UNITED STATES PATENT AND TRADEMARK OFFICE

APPLICATION NO.	FILING DATE	FIRST NAMED INVENTOR	ATTORNEY DOCKET NO.	CONFIRMATION NO.
09/921,660	08/03/2001	Klaus Heckel	22750/488	8200

Office Action Summary

DETAILED ACTION

FIG. 5

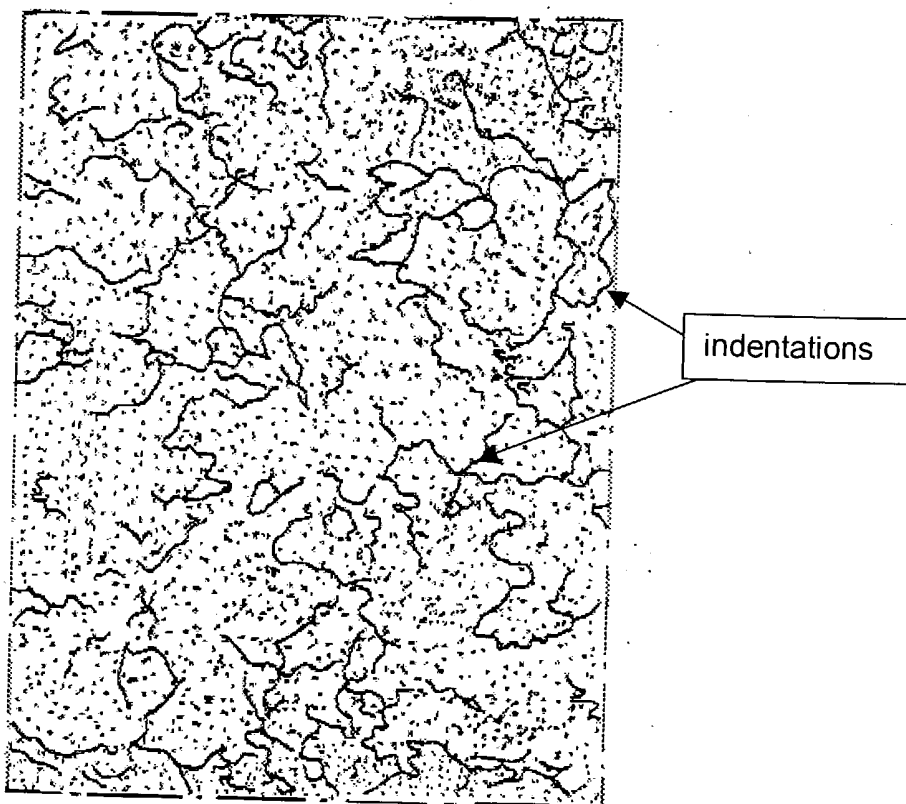
Regarding **claims 5 and 6**, note each indentation intersects at least two other indentations (see Figure 5 shown below). Regarding **claims 8 and 9**, note the indentations have shapes that differ one from the other (see Figure 5 shown below). Regarding **claim 11**, note the surface percentage of the indentations is 5% to 50% of the total surface of the floor covering (see Figure 5 shown below). Regarding **claim 12**, note the surface percentage of the indentations is 20% to 40% of the total surface of the floor covering (see Figure 5 shown below). Regarding **claim 13**, note the indentations have the same depth over their entire length (see col. 6, lines 15-17). Regarding **claim 14**, note the remaining surface of the floor covering is essentially planar (see Figs. 3a-3d). Regarding **claim 15**, note the width of the individual indentations varies (see Fig. 3b). Regarding **claim 16**, note the length of the individual indentations varies (see Fig. 5 shown below). Regarding **claim 18**, note the floor covering is assembled from individual, repeating surface units (see col. 6, lines 26-30). Regarding **claim 19**, note the floor covering is made up of a single-layer material (see col.5, lines 55-61). Regarding **claims 20 and 21**, note the floor covering has a thickness in the range of 2 mm to 5 mm and in the range of 2.5 mm to 4 mm (see col. 11, lines 31-32).
